- 5. The Lady L Ranch; KPB File 2022-123  
Segesser Surveys / Short  
Location: Tanadak St. & Jackson Ave.  
Kalifornsky Area**

KPB File # 2022-123  
S28 T04N R11W  
Kalifornsky

ITEM 5 - THE LADY L RANCH

**STAFF REPORT**

The Lady L Ranch

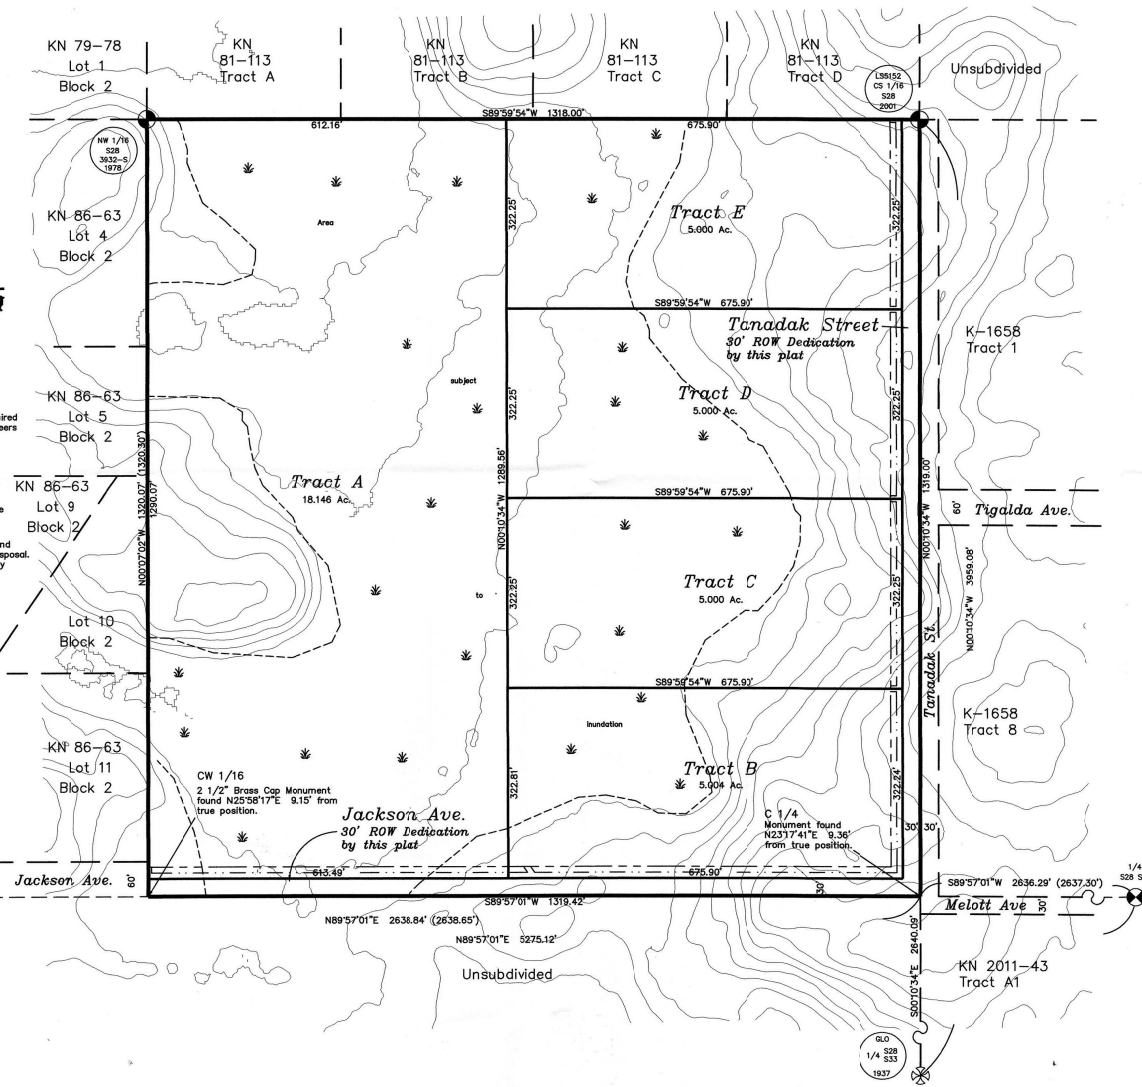
**recommends** the right-of-way be depicted within the subdivision with a reference label to either a plat note or a label stating “50 foot right-of-way permit, ADL 63002, as found in Book 117 Page 554, KRD.”

**Site Investigation:** There are low wet areas present in the proposed plat that are depicted. Per KPB GIS imagery, there may be areas with open water. **Staff recommends** the status of the open water be determined and depicted on the plat and label as pond, seasonal pond, etc., and wetlands remain on the final plat.

Slopes are depicted on the plat. There is a solid dotted lines that appear on the plat but it is not labeled or within the legend. **Staff recommends** label the line to indicate what that line represents if it is for the top or toe of bluff that it remain on the final plat.

The slopes within Tanadak Street and Jackson Avenue appear to exceed allowable slopes for rights-of-way. **Staff recommends** the surveyor verify the slopes are compliant and if they exceed allowable slopes provide centerline profiles and cross-section analysis to determine if additional widths or slope easements are required.

there will be more than 40,000 square feet of upland area. **Staff recommends** the overall acreage and upland acreage for each lot be labeled on the final.

**Utility Easements** The parcel within this subdivision has not had a plat done and thus no utility easement granted by plat exist. The plat is proposing a 10 foot utility easement along the dedicated rights-of-way that increases to 20 feet within 5 feet of the side lot lines. **Staff recommends** the depiction of the utility easement between Tract A and Tract B be adjusted.

- Provide Basis of Bearing
- Plat note 3 needs to be changed to 3 from 4.
- Add distance and bearing to line to west at southwest corner of plat

- Staff recommendation:** *Check acreage, not sure total is 40.000 acres*
- D. A vicinity map, drawn to scale showing location of proposed subdivision, north arrow if different from plat orientation, township and range, section lines, roads, political boundaries, and prominent natural and manmade features, such as shorelines or streams;

- Staff recommendation:** *Rex's Road was renamed to Tote Road to the intersection with Leisure Lake Dr. Update the label.*
- G. The status of adjacent lands within 100 feet of the proposed subdivision boundary or the land status across from any dedicated rights-of-way that adjoin the propose subdivision boundary, including names of subdivisions, lot lines, block numbers, lot numbers, rights-of-way; or an indication that the adjacent land is not subdivided;

- Staff recommendation:** *Lot 10 on the west, add the subdivision notation, update Tract C to the north to Lot 2 from Plat KN 2001-65.*

- Staff recommendation:** *Review the slopes within the proposed dedications and provide centerline profiles and cross-sections if they do not comply to determine if additional width or slope easements are required.*

- Staff recommendation** *Start the right-of-way dedication of Jackson Avenue on the west side at the 60' point as is shown for the dedication from Hideaway Heaven. Continue east across plat to a point that is 30 feet north and 30 feet west of the southeast corner of the property; also, being the intersection point for Tanadak Street and Jackson Avenue, this will pick up some of the existing drive/road on the west side of the dedication.*

- Include the reference to KPB Code in plat note 4, "(KPB 14.06)".
- Add plat notes if the structure is within the setback and utility easement.
